LiDAR Quality Assessment Report

FL_Osceola_2015

2016-12-07

Checkpoint Distribution Image

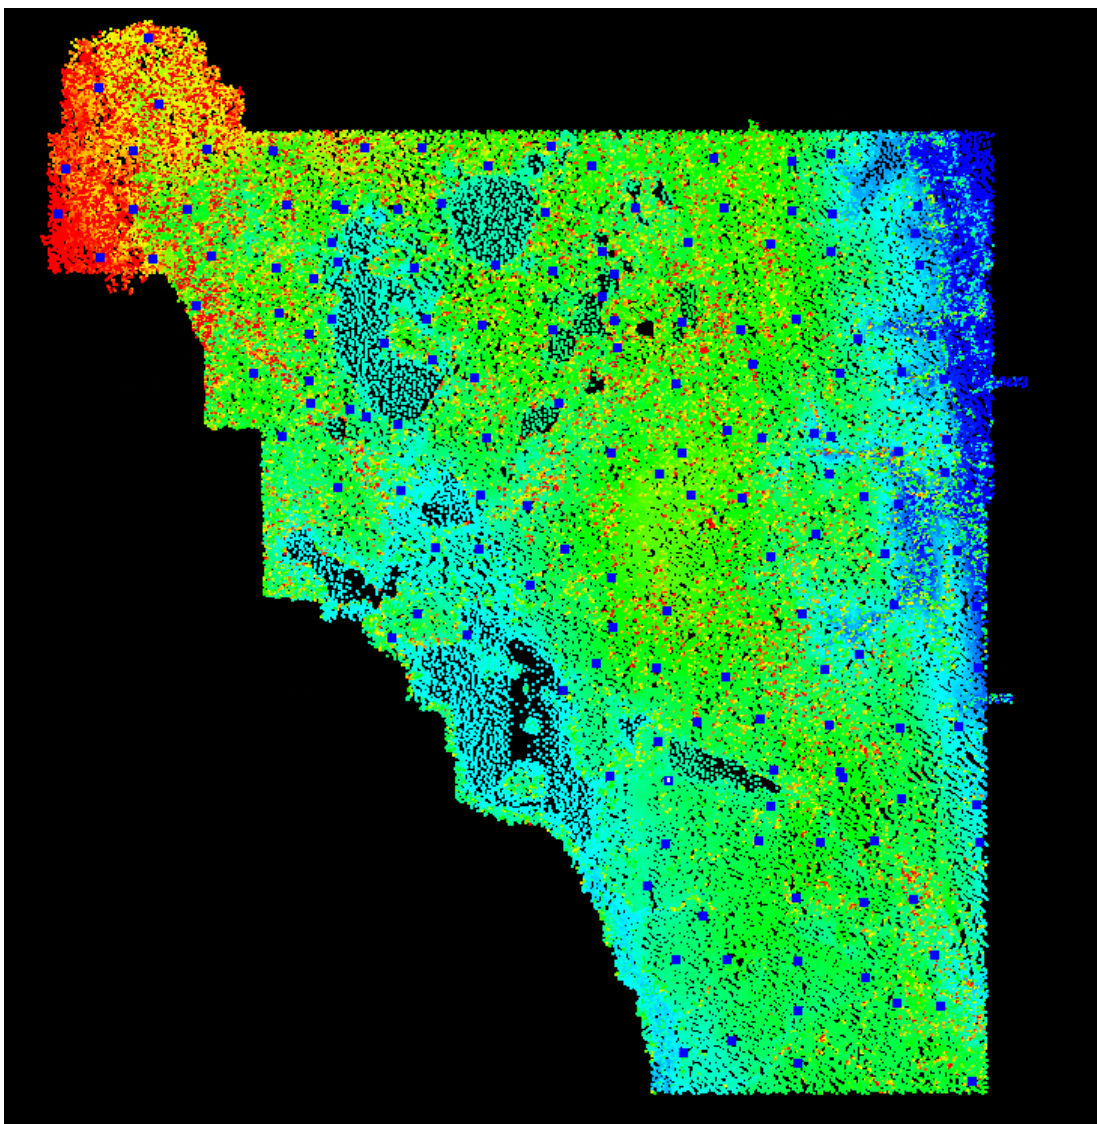
Checkpoints are well distributed?

Enough checkpoints for task order?

Checkpoints meet USGS LiDAR base-spec in quantity and quality?

Based on this review, the USGS accepts the vertical accuracy.
